**WHEELING PLAN COMMISSION
THURSDAY, JANUARY 25, 2018 6:30 P.M.**

REQUEST FOR PLAN COMMISSION ACTION
STAFF PROJECT REVIEW

RE: **Docket No. SCBA 18-3**
Boston Fish Market
412 N. Milwaukee Avenue
Appearance Approval of Wall & Freestanding Signs

RE: Docket Nos. 2017-18 and SCBA 18-4
Shri Swaminarayan Temple
397 Northgate Parkway
(2017-18) Special Use-Site Plan Amendment to Allow for a
Building Addition
(SCBA 18-4) Appearance Approval of a Freestanding Sign

Landscaping Plan -

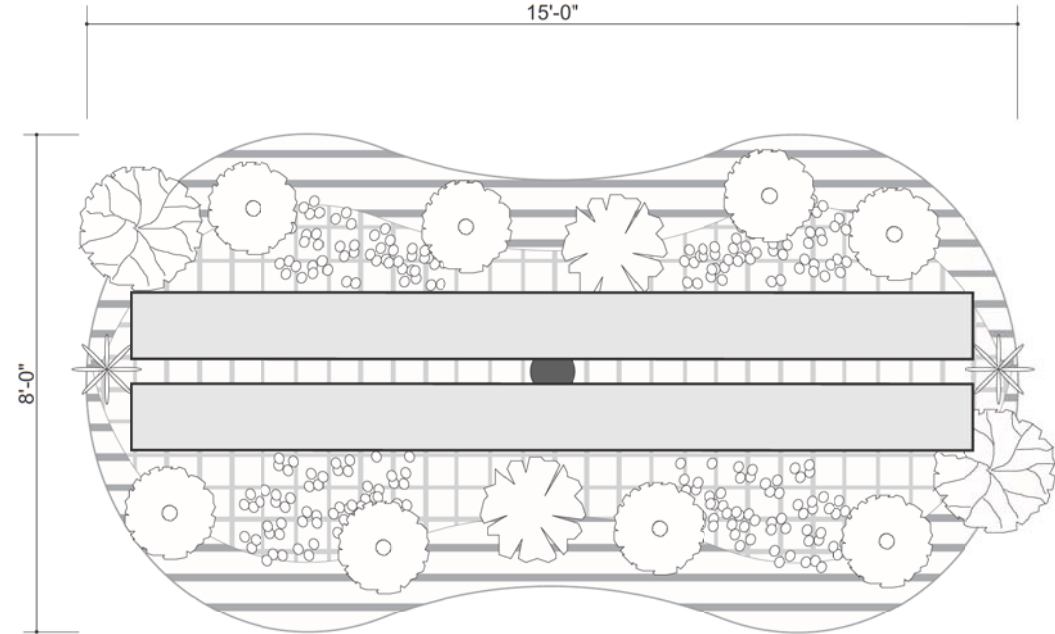
Landscaping: A landscape plan is proposed for the freestanding sign. The proposed landscaped area is approximately 120 sq. ft. The required area is twice the sign area, which is 137 sq. ft. In addition to the proposed landscaped area, there are existing shrubs in the immediate vicinity that may also count towards the required landscape area. As such, it appears that the required size of the landscaped area is met. The proposed landscape plan meets the species mix requirements of the Sign Code. It includes evergreens and winter interest (Bigleaf Evonymus), flowering perennials (Happy Return Day Lily, Walker's Low Catmint, Sedum), deciduous shrubs (rose bushes), and ornamental grasses (Karl Forester).

LANDSCAPE PLAN

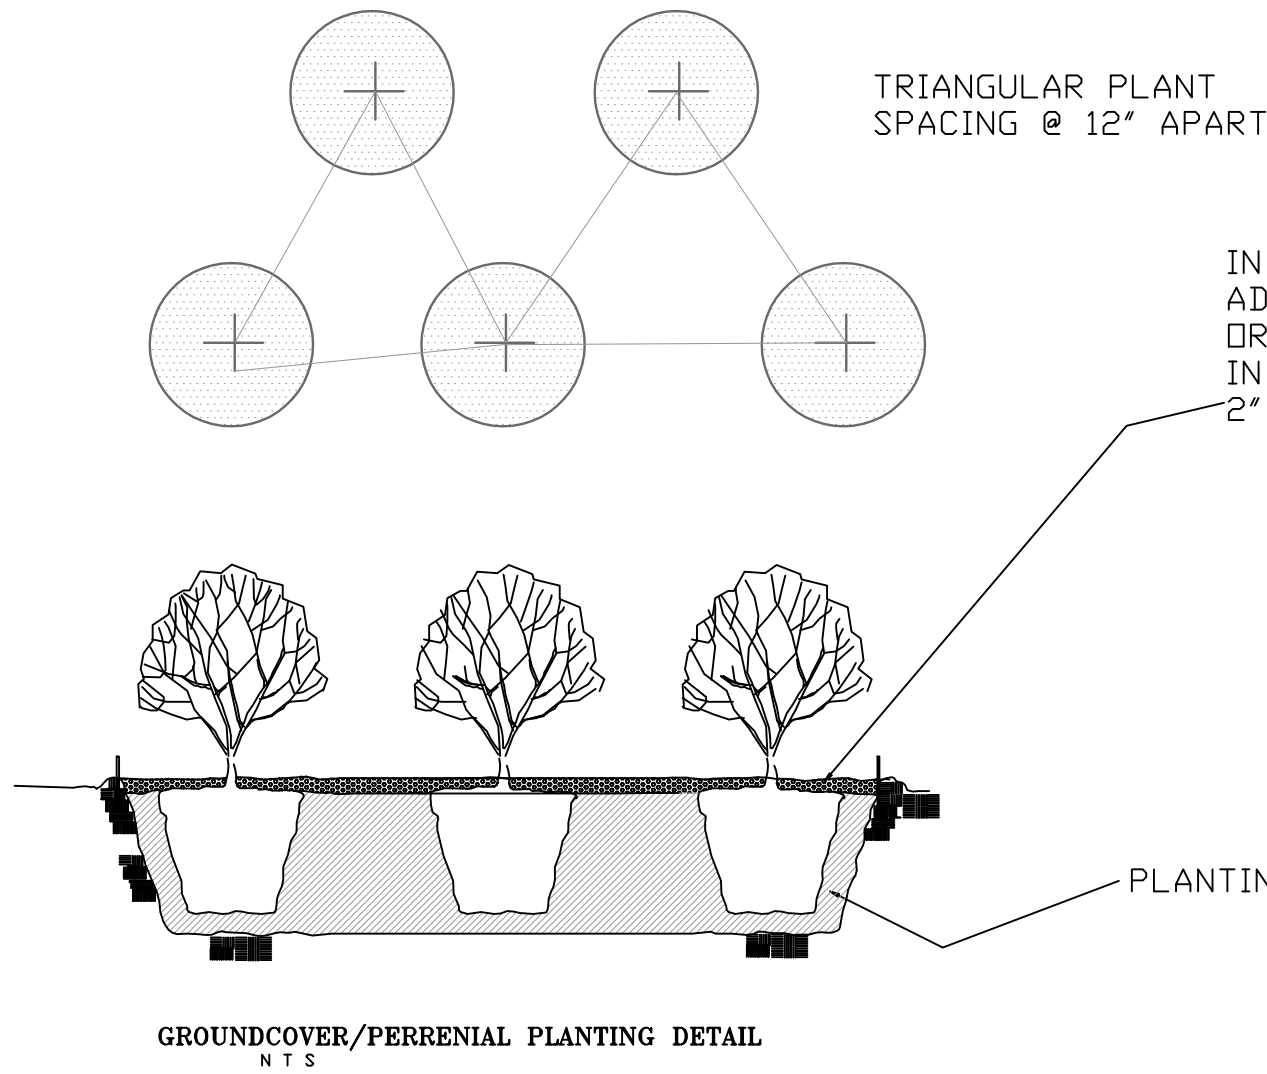
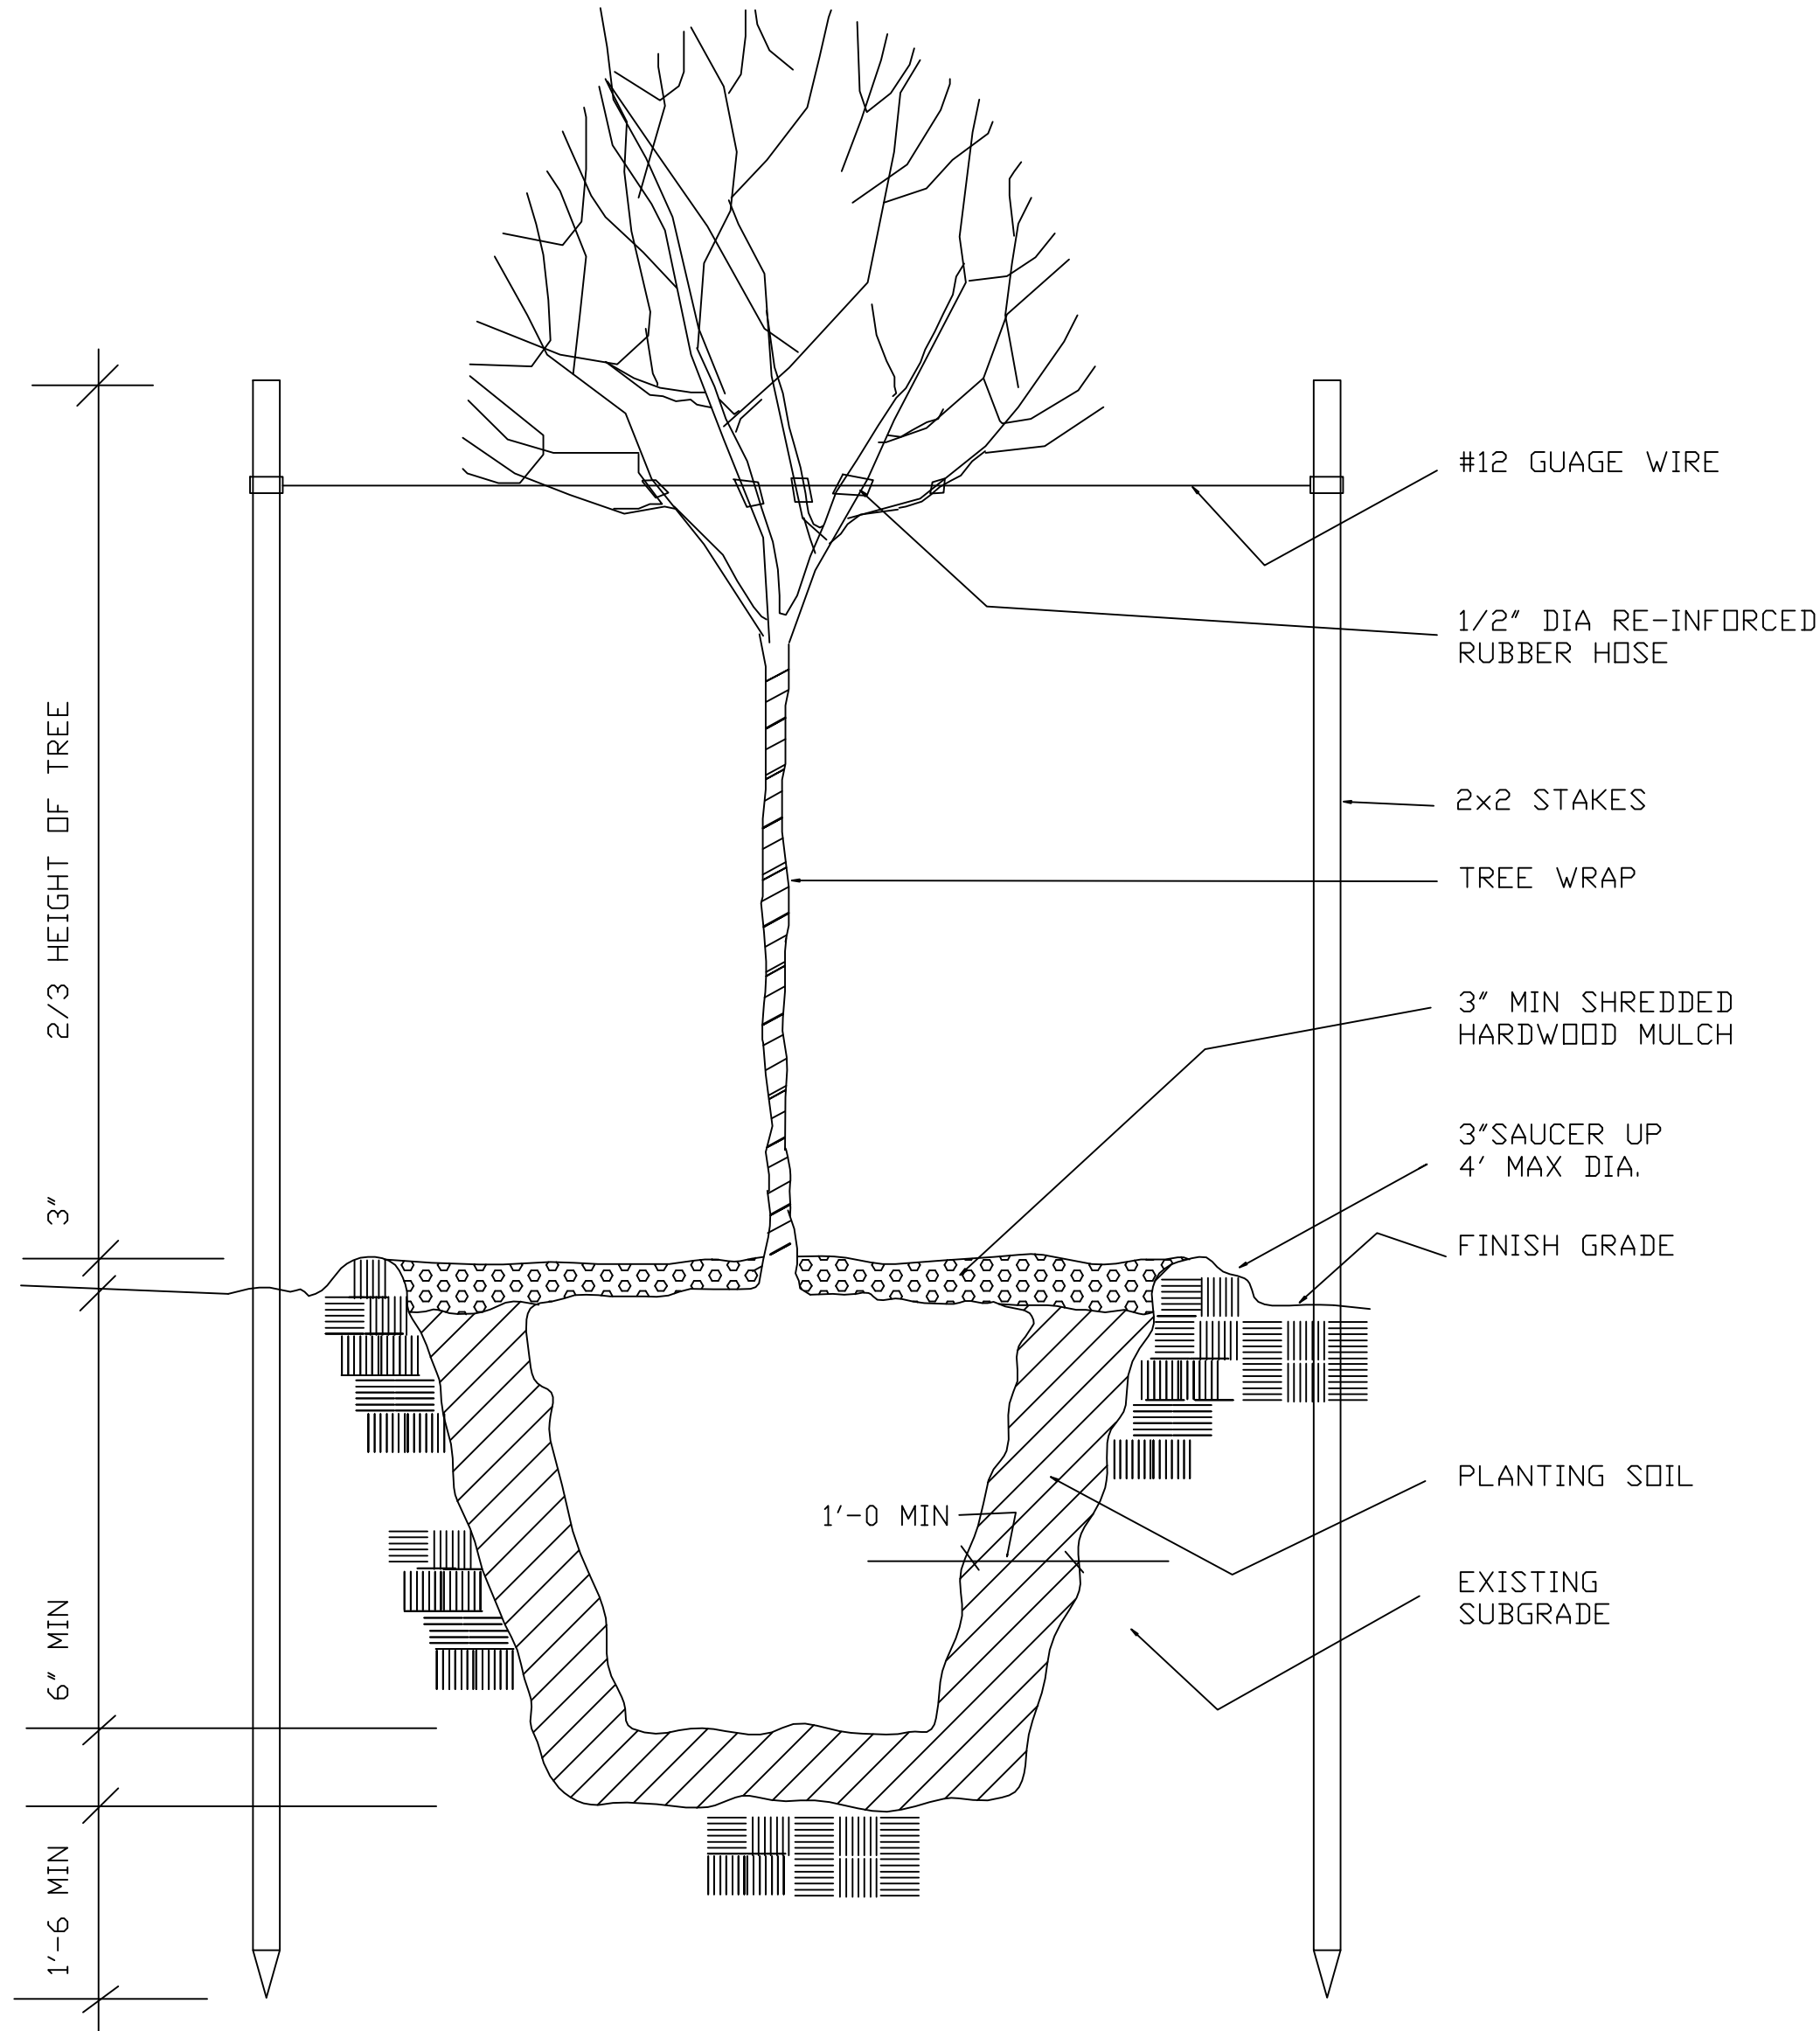
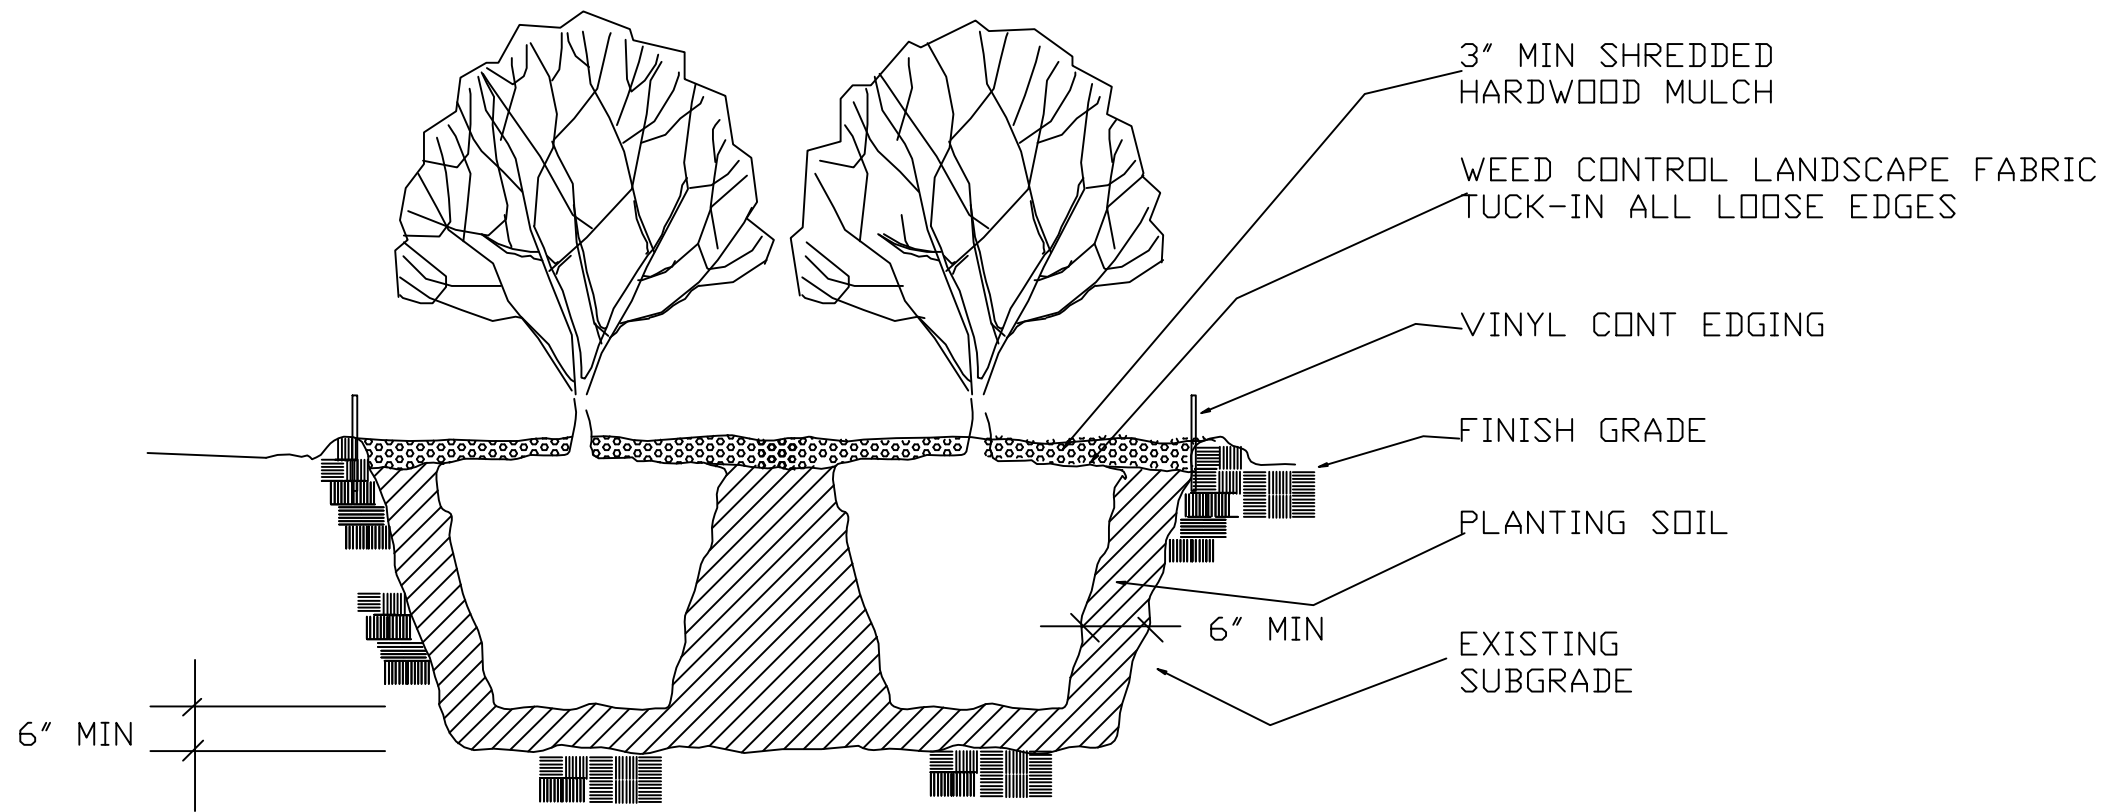
Existing Landscaping to Remain: The existing and demolition plan (within the engineering plans) indicates several trees will be removed on the east side of the property. The foundation plantings on the south and west sides of the existing temple and the existing landscaping along Northgate Parkway and surrounding the south parking lot of Lot 1 will remain.

Proposed Landscaping: Foundation plantings are proposed for areas surrounding the new 25,075 sq. ft. addition and include a mix of flowering perennials, deciduous shrubs, and evergreen shrubs. The interim plan for the pad of the future (Phase II) 14,500 sq. ft. addition is grass sod. Immediately north and south of the sodded area are landscaped beds with a mix of trees, shrubs, and perennials. Canopy trees are also planned along the outside of the new looped access drive.
